**STATE OF TENNESSEE
DEPARTMENT OF TRANSPORTATION**

INSTRUCTIONAL BULLETIN NO. 20-01

Regarding Revised and New Standard Drawings.

Effective May 15, 2020 letting (March 4, 2020 Turn-in), the following standard drawings have been revised and are new. Section 10 of the Roadway Design Guidelines has also been revised to incorporate these new standard drawings.

**32" CONCRETE
 BARRIER WALL WITH
 SINGLE GUARDRAIL
 ATTACHMENT**

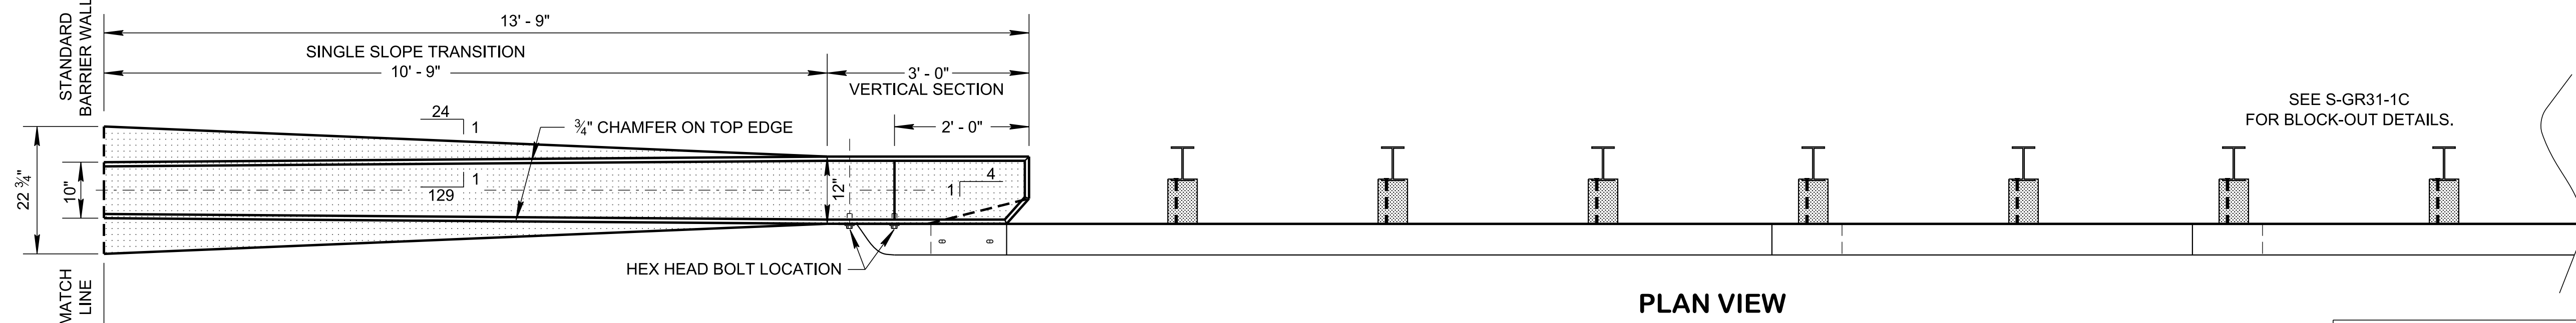
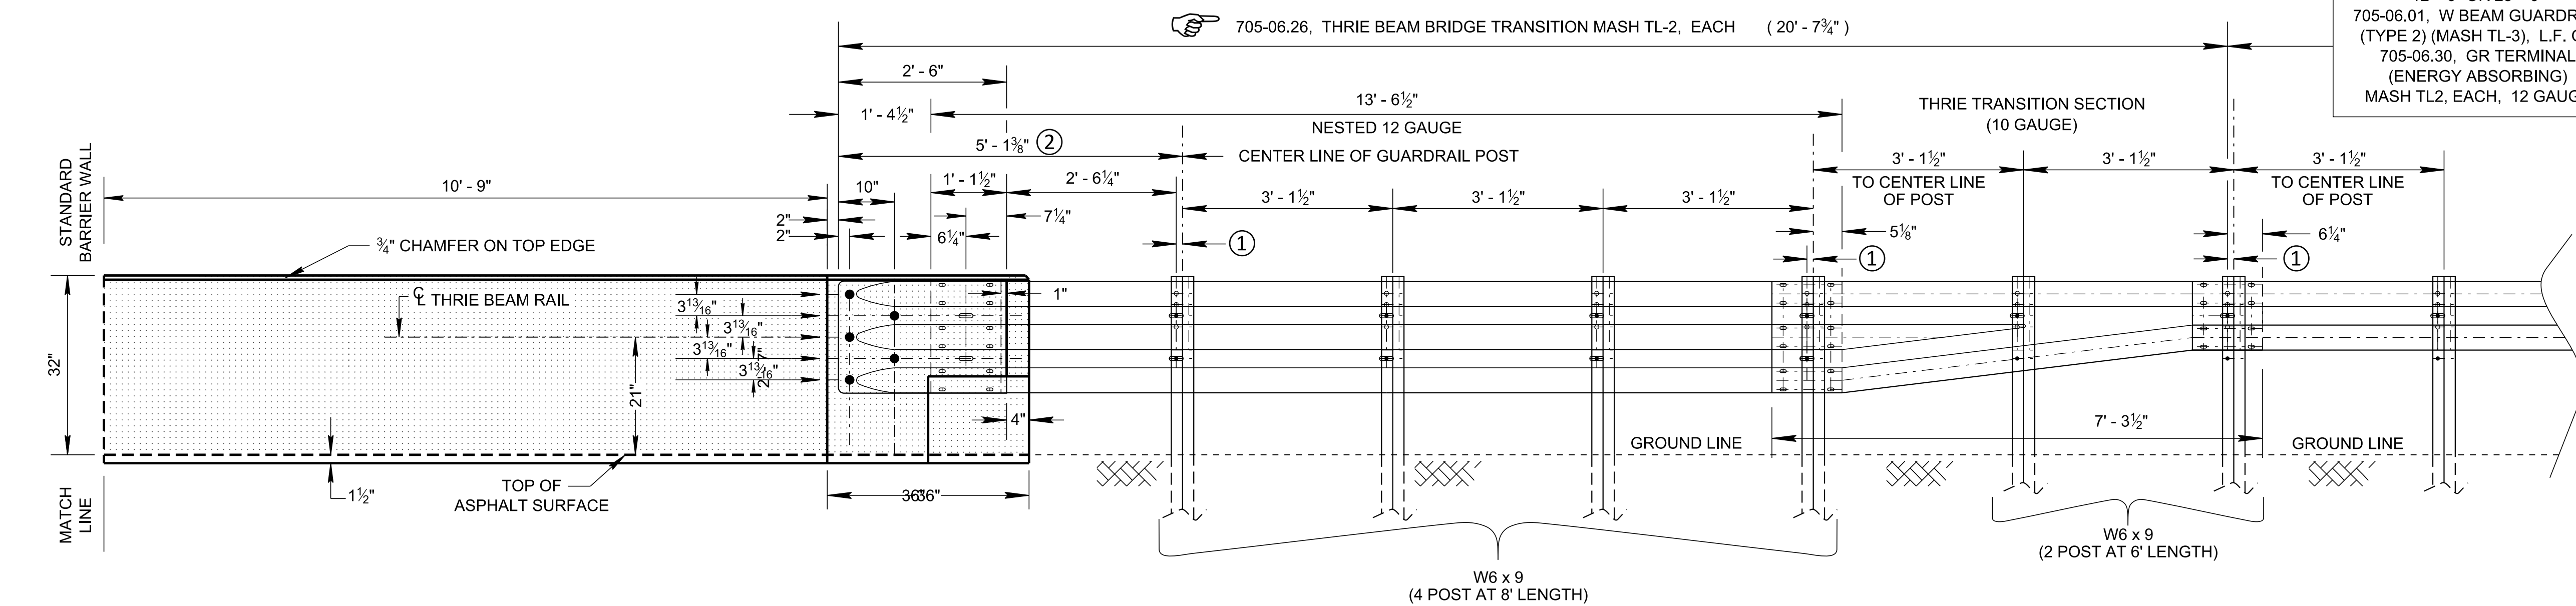
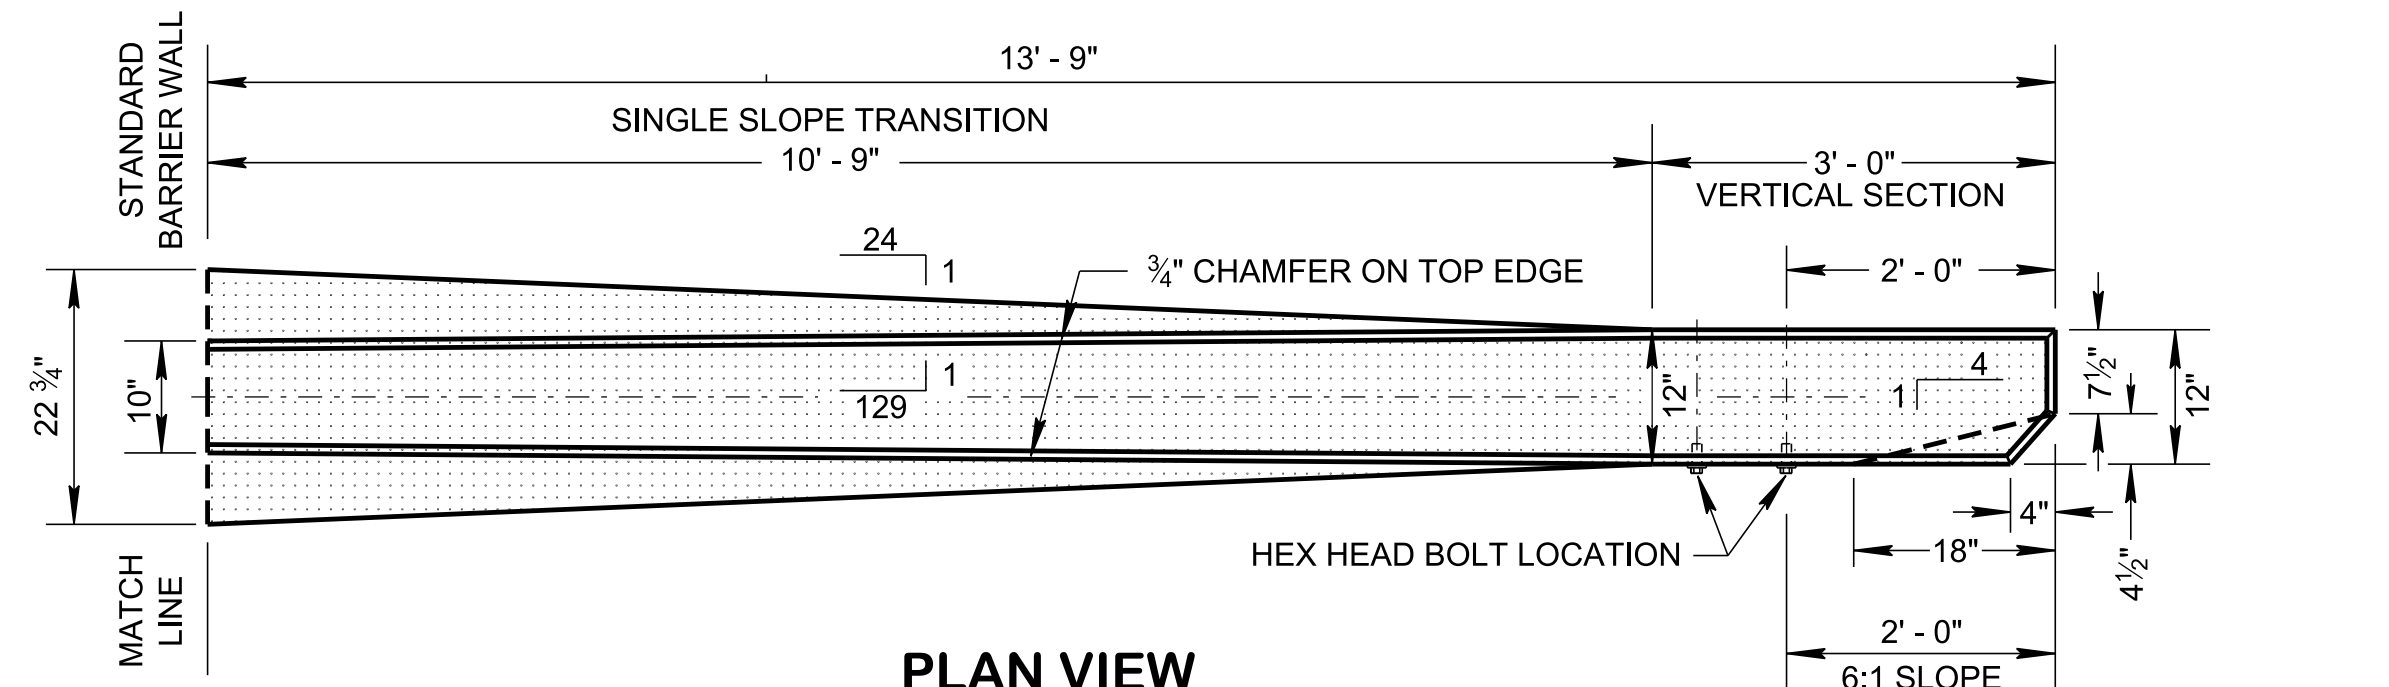
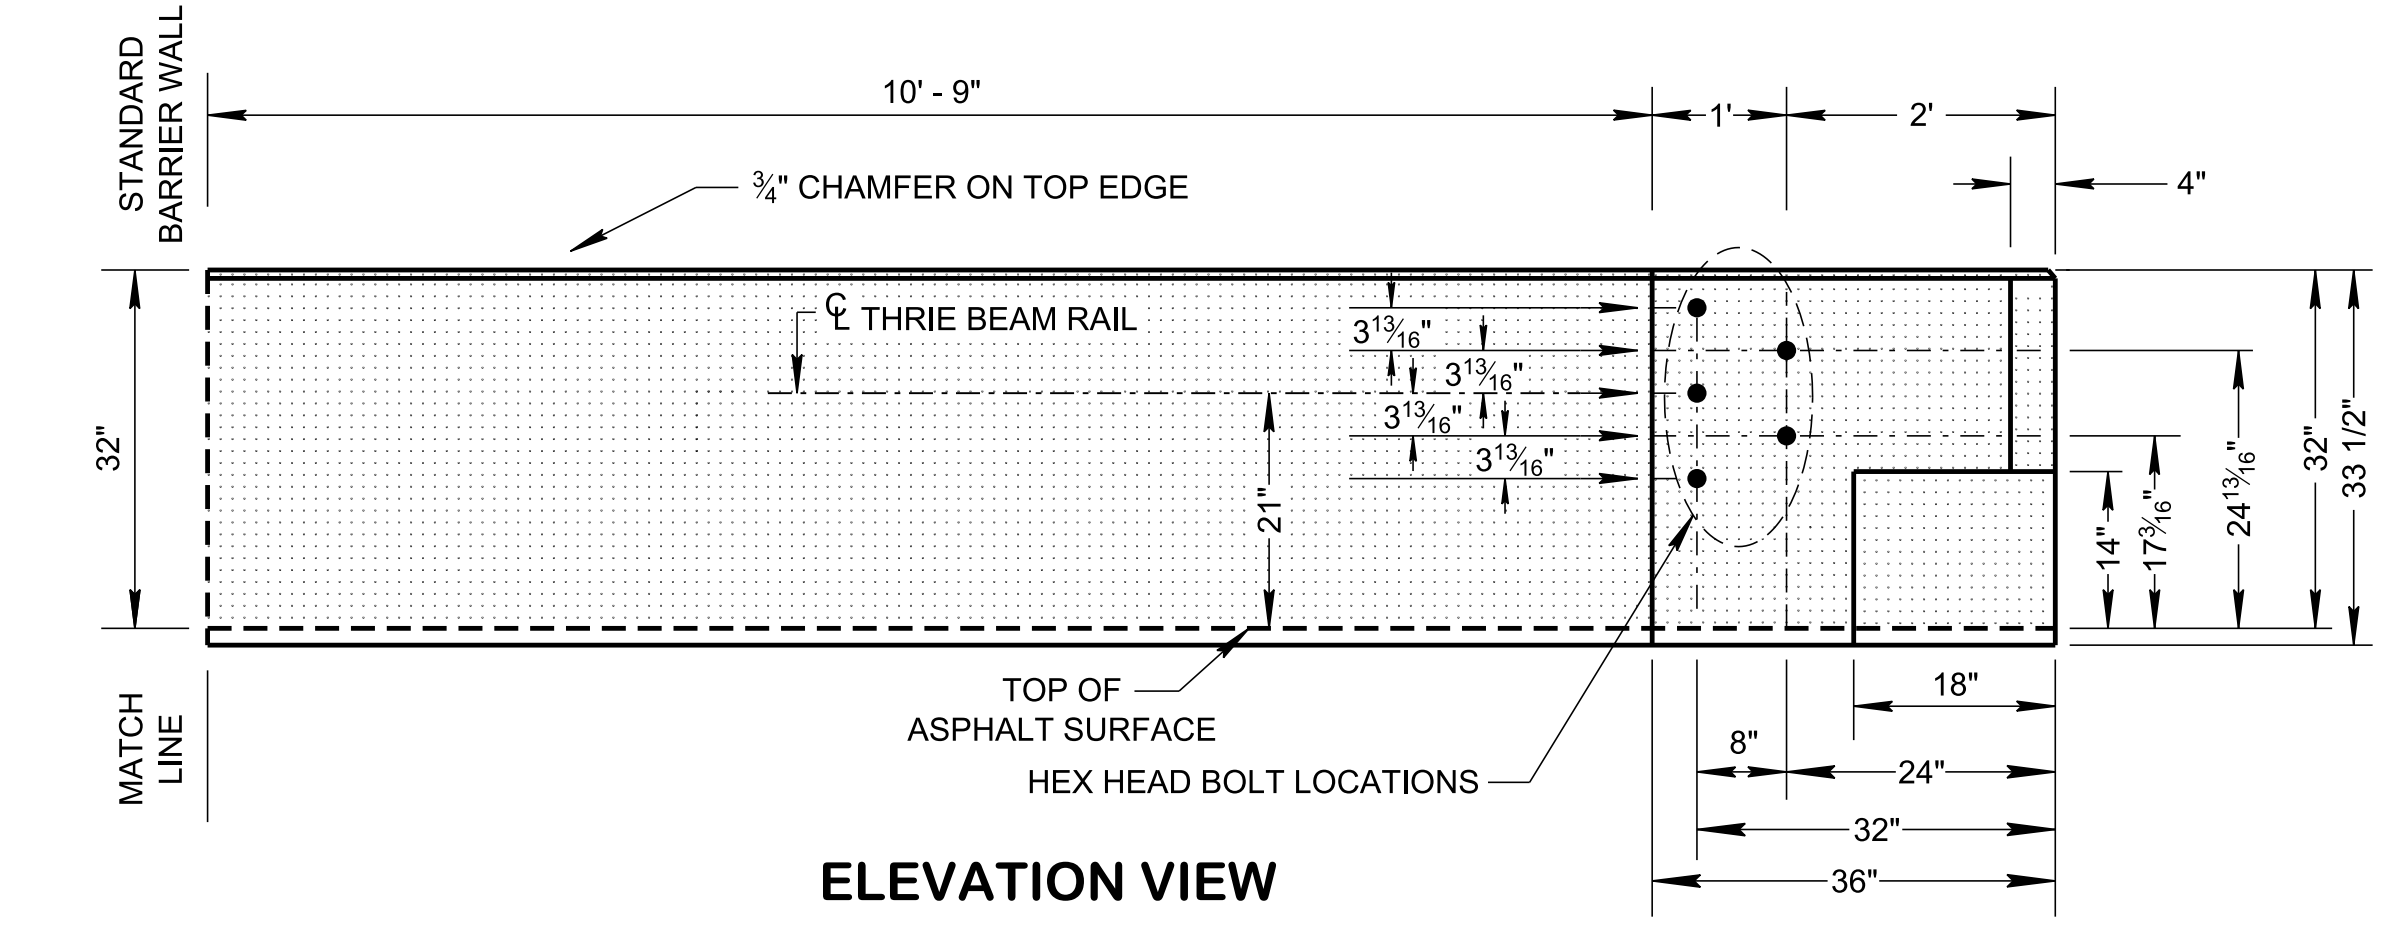
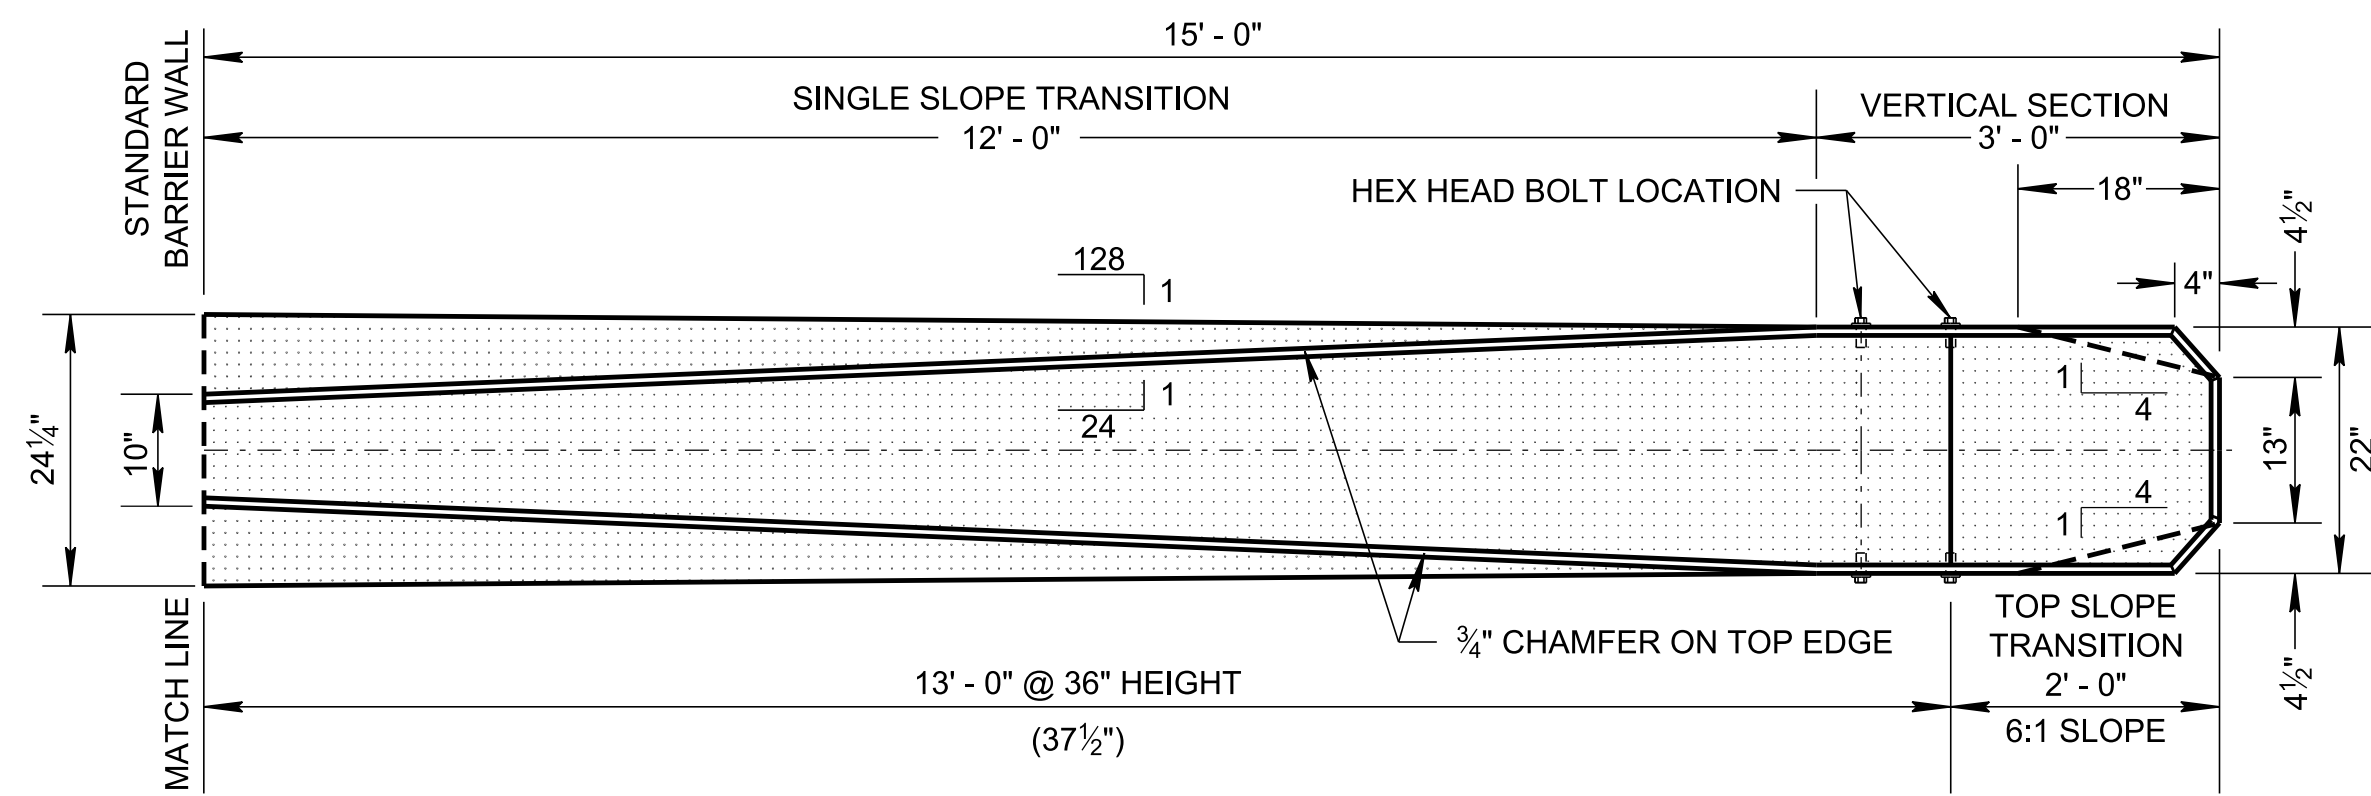
REV. 10-24-13: DELETED NOTE 6.
 REV. 05-27-16: ADDED ALTERNATE CROSS-SECTION DETAILS. REVISED DIMENSIONS. CORRECTED GENERAL NOTES.
 REV. 06-28-19: REMOVED 51" BARRIER WALL. REPLACE ALL NOTES AND DETAILS. CHANGED DRAWING NAME AND REDREW SHEET.
